Campaign No. 2010110008, January 2011

SUBJECT: **Model 463, Model Years 2002 - 2010**  
**Remove Headlamp Grill, Replace Front Turn Signal Lenses**

Figure 1

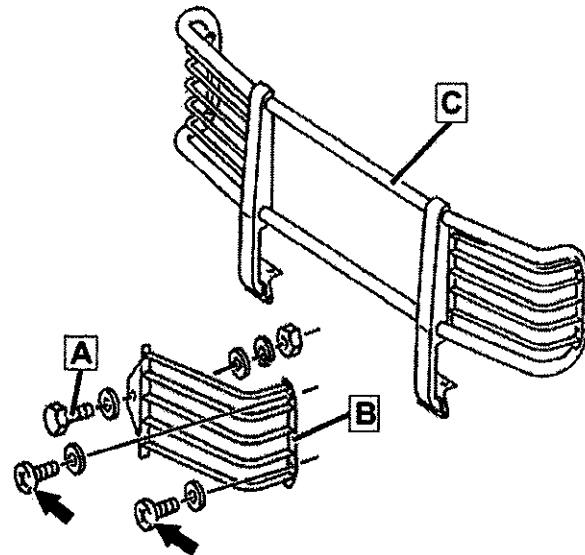
### 2. Remove headlamp grill (B, Figure 1):

- Remove bolt (A) and two screws (arrows) then remove headlamp grill (B) from front brush guard (C). Repeat this step on opposite side.
- Clean area of brush guard where headlamp grills (B) were installed.

- Brush guards must **not** be installed again
- All parts removed in this step **must** be returned to the QEC.
- Cost of parts removed in this step must be reimbursed to customer. Refer to parts reimbursement table on page 4.
- Cost of aftermarket (non Mercedes-Benz genuine) parts removed in this step must **not** be reimbursed to customer.

Figure 3

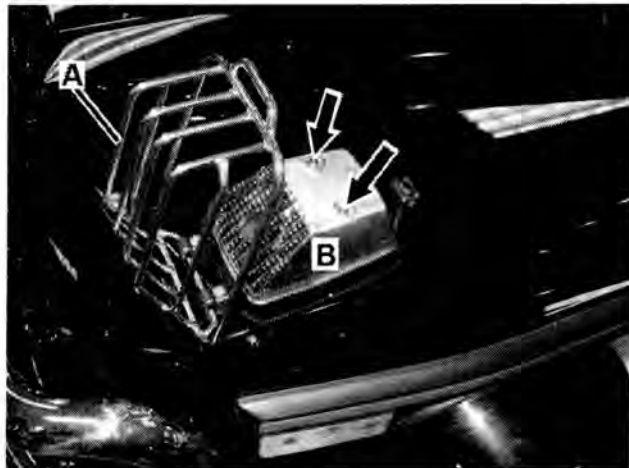
4. Replace front turn signal lenses (B, Figure 3):
  - Open directional grill (A).
  - Remove 2 screws (arrows) then remove lens (B).
  - Install new lens (B) in reverse order.

Use only **hand tools** to tighten screws (arrows), do **not** over-tighten screws (arrows).
